# Service Bulletin

Bulletin No. 2009-08  
OEM No. 2009-07

## Wire Chafing 2.5 Liter OptiMax

41012

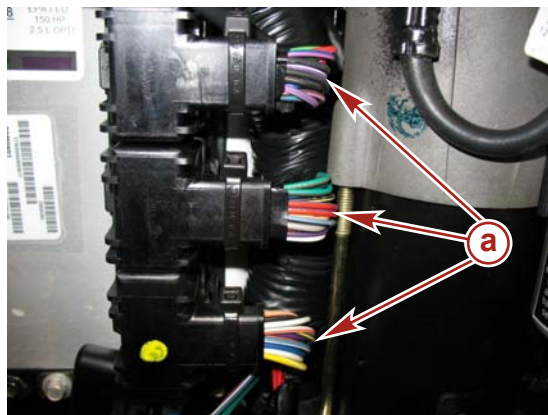
Some engines in the listed serial number range have had the harness routing corrected prior to shipping. First, check engine history on MercNET or contact Mercury Outboard Technical Service at 920-929-5884. If the engine history indicates the harness routing has been corrected and the fix campaign closed, no further action is required. Engines reworked at the factory will have a GREEN dot on the engine carton near the serial number label. If the engine is no longer in the engine carton, remove the top cowl and look for a GREEN paint dot on the propulsion control module (PCM). If a GREEN dot is found on the engine carton, or on the PCM, no further action is required. If the engine history indicates an open campaign and there is no GREEN dot on the engine carton or PCM, check for 6.35 mm (1/4 in.) of clearance between the PCM wire bundles and the starter motor. If there is insufficient clearance between the wires and the starter, reposition the wires using the following procedure.

**a** - PCM wire bundles – center bundle contacting starter motor

1. Remove the three PCM harness connectors from the PCM and remove the harness from the J-clip above the PCM.
